### SANTA ANA RIVER TRUNK SEWER REPLACEMENT PROJECT - PHASE II

# AS-BUILT

## JANUARY 3, 2017

**SANTA ANA RIVER TRUNK SEWER REPLACEMENT - PHASE II**  
**COVER SHEET**

ACCT. NO.: 9799123  
S-2089  
SHEET 26 OF 35  
FILE NO. SARTS\_SHT26.DWG

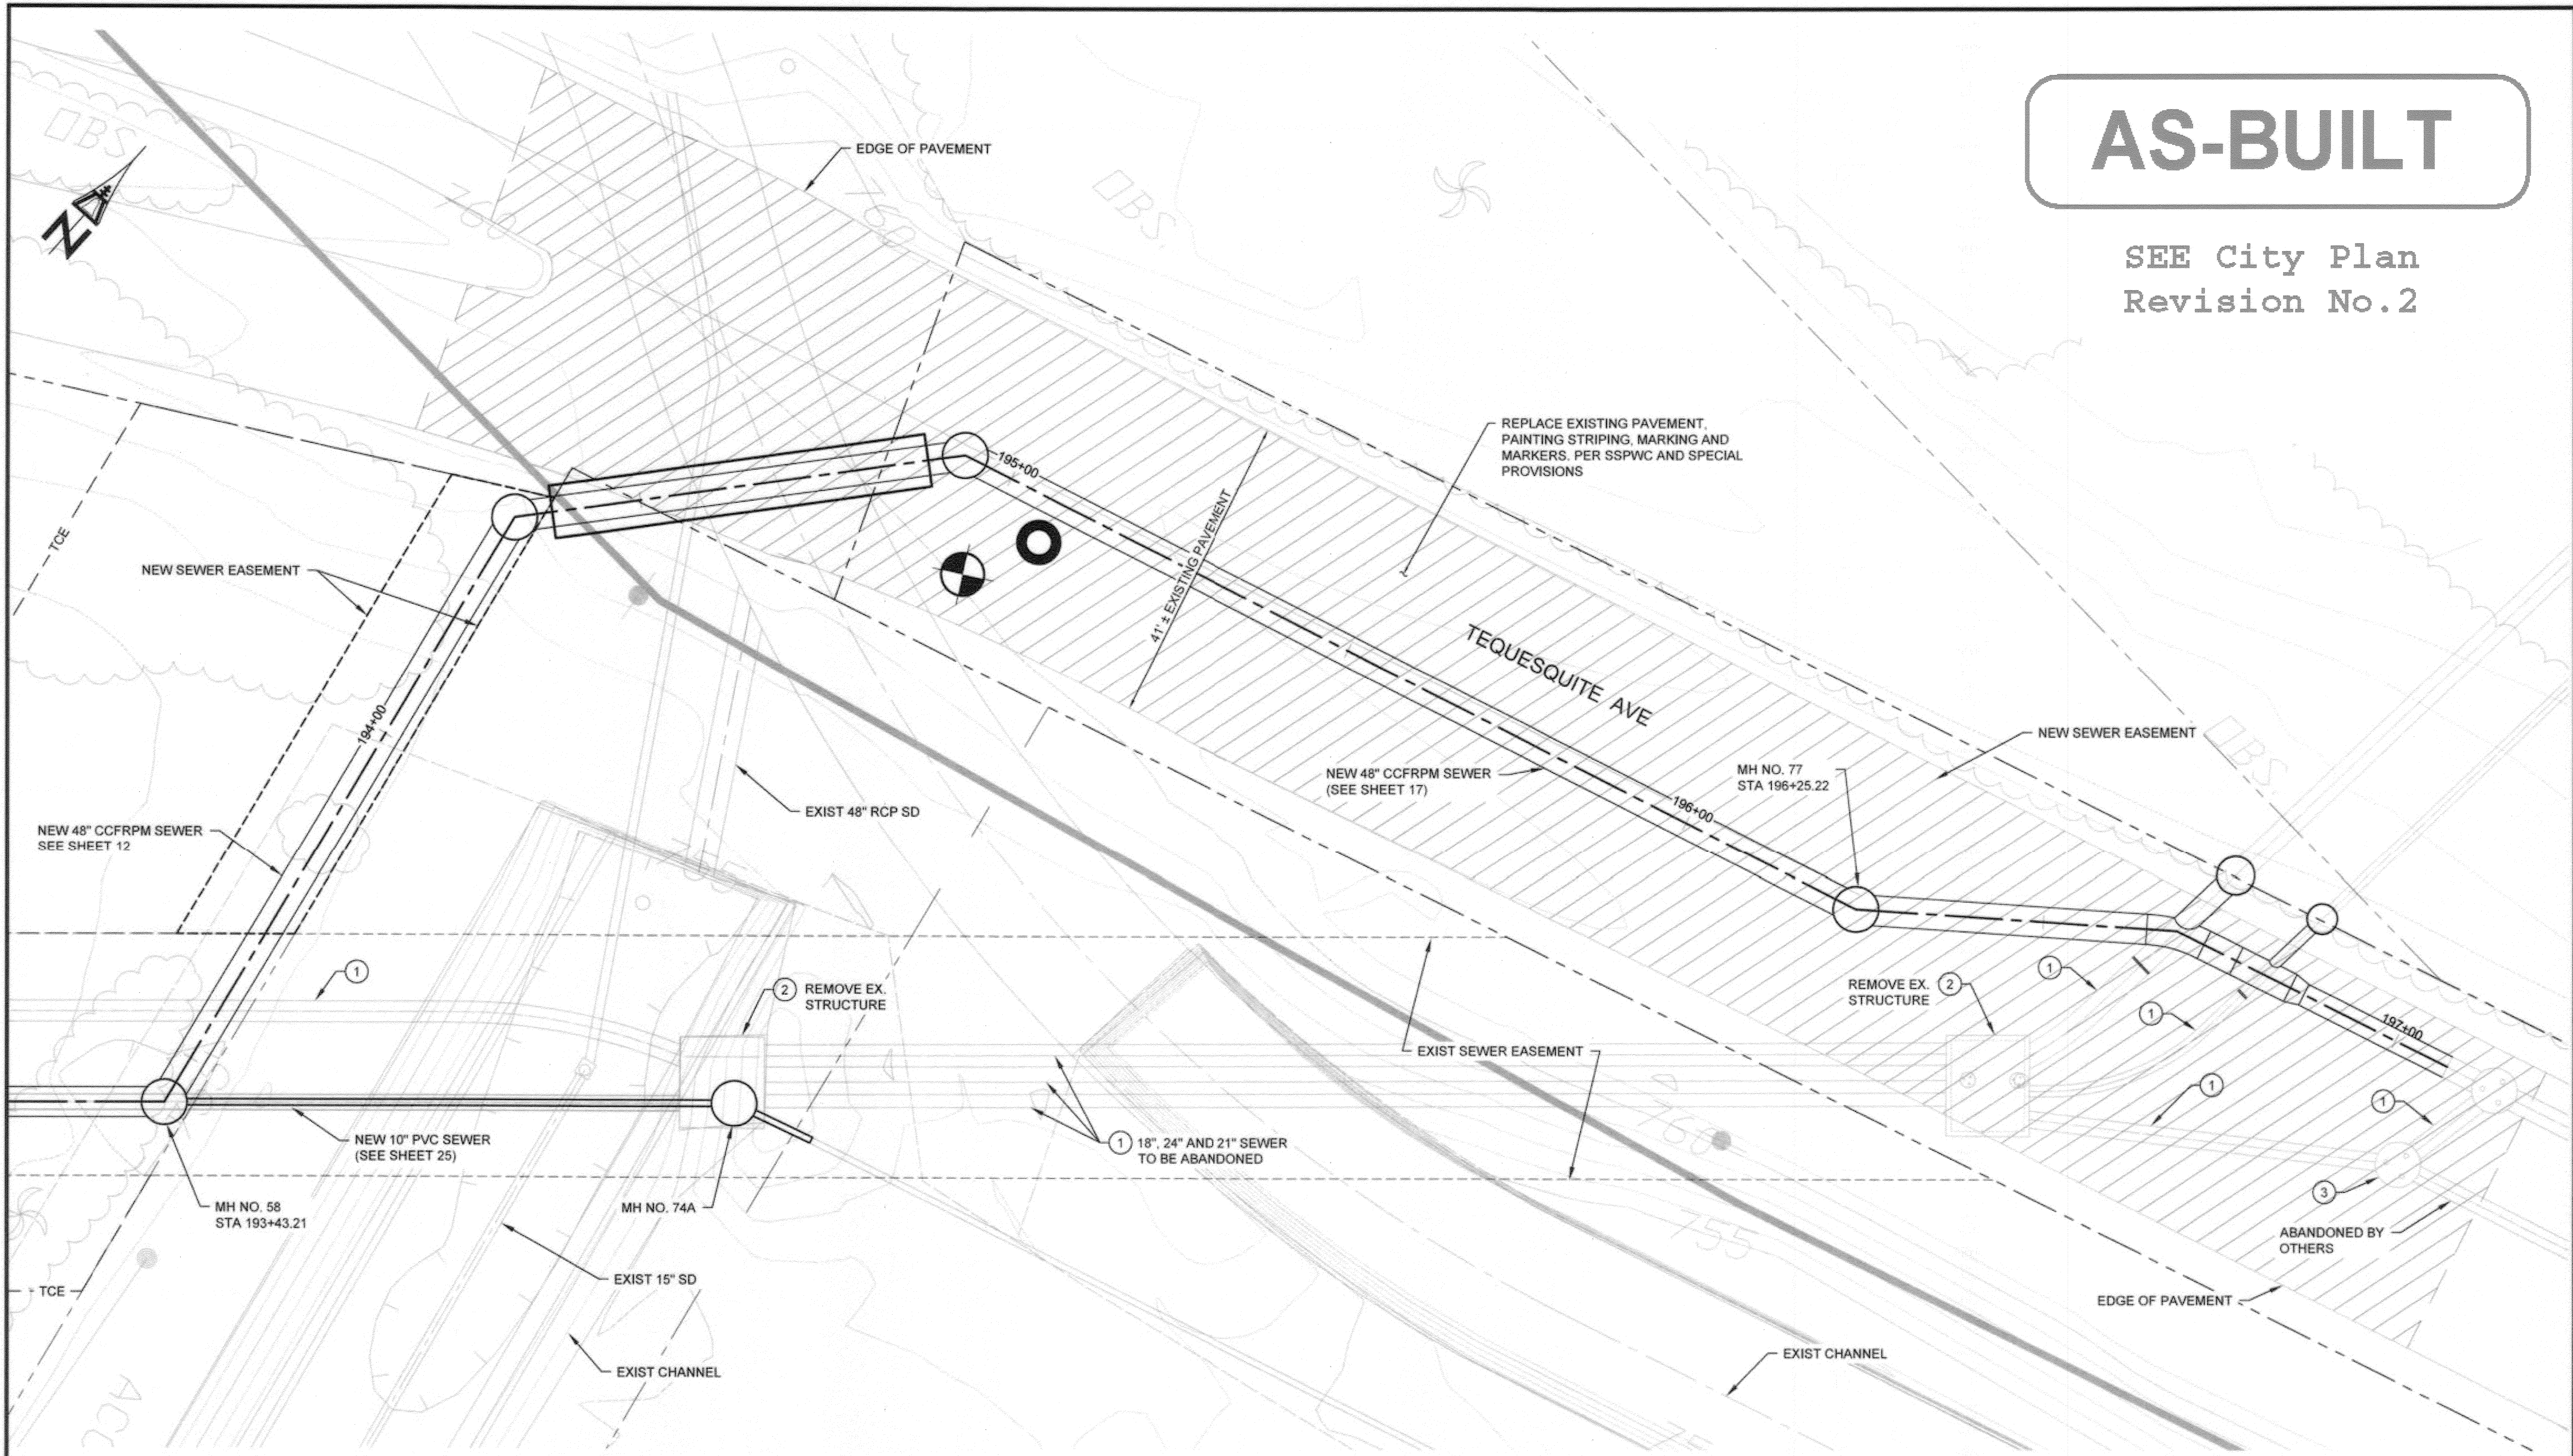
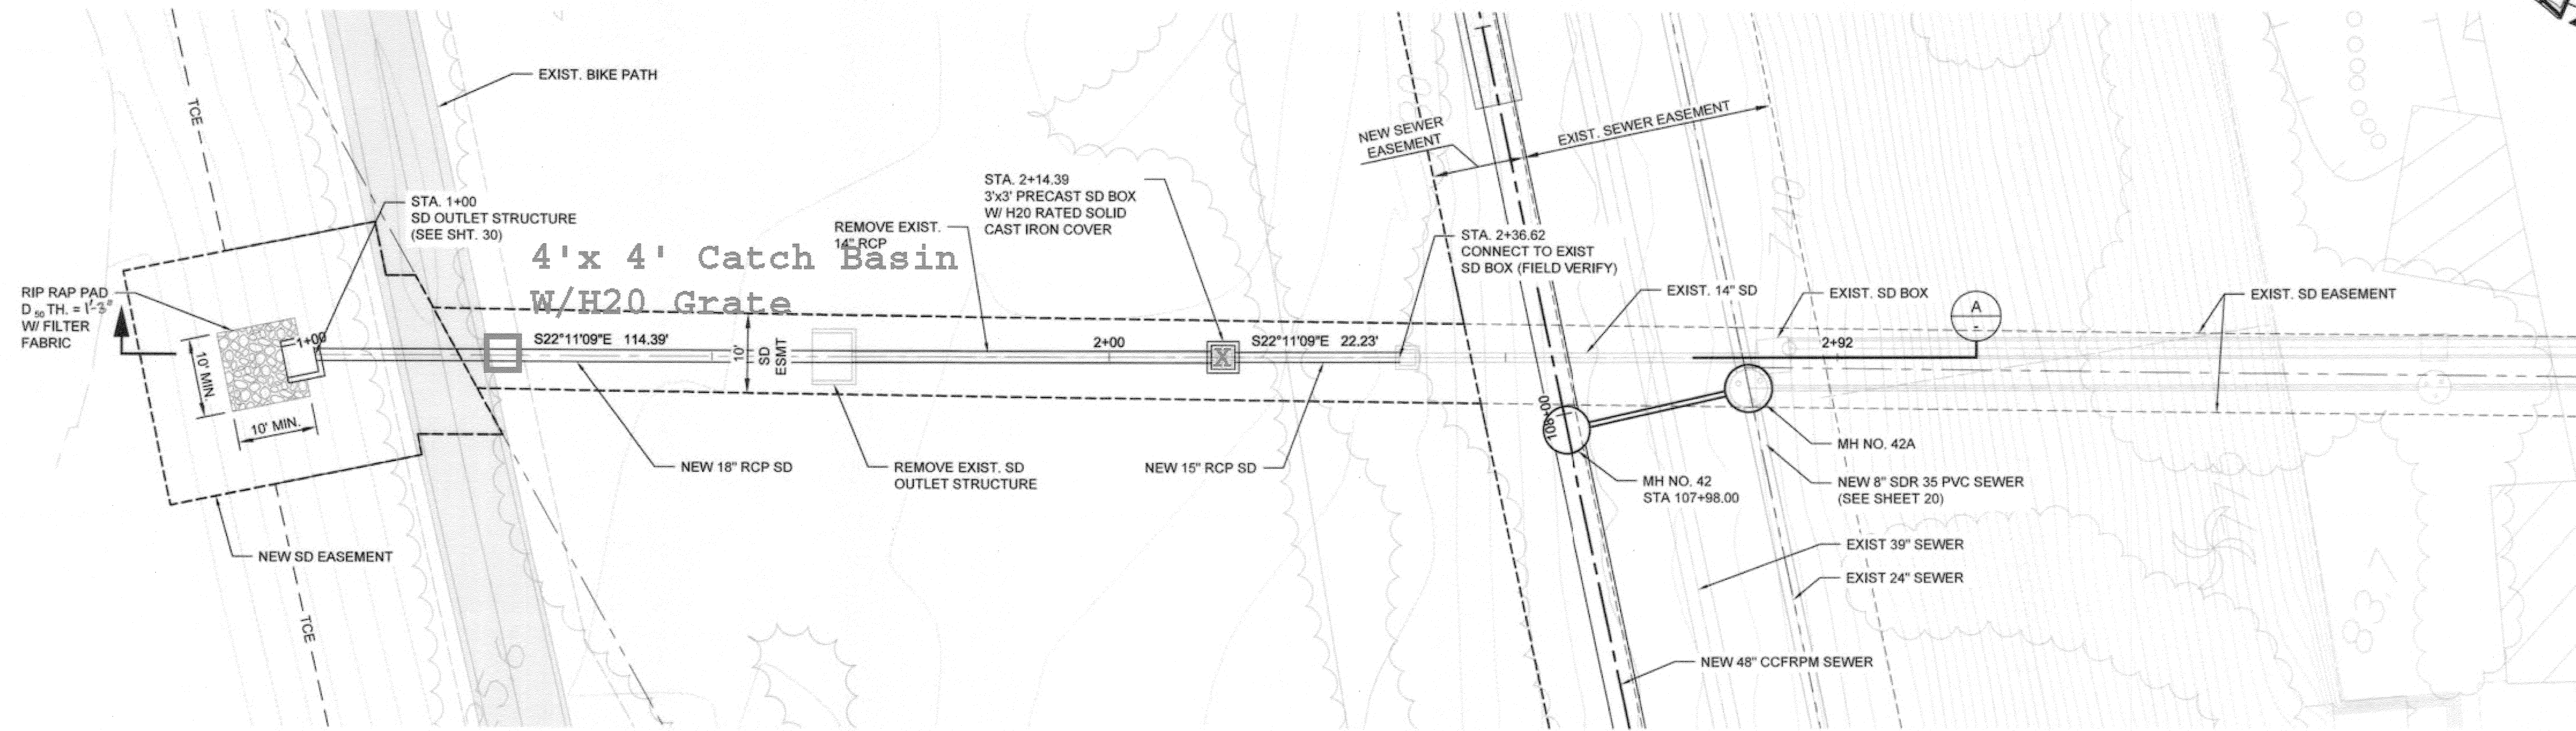
SEE City Plan  
Revision No.2
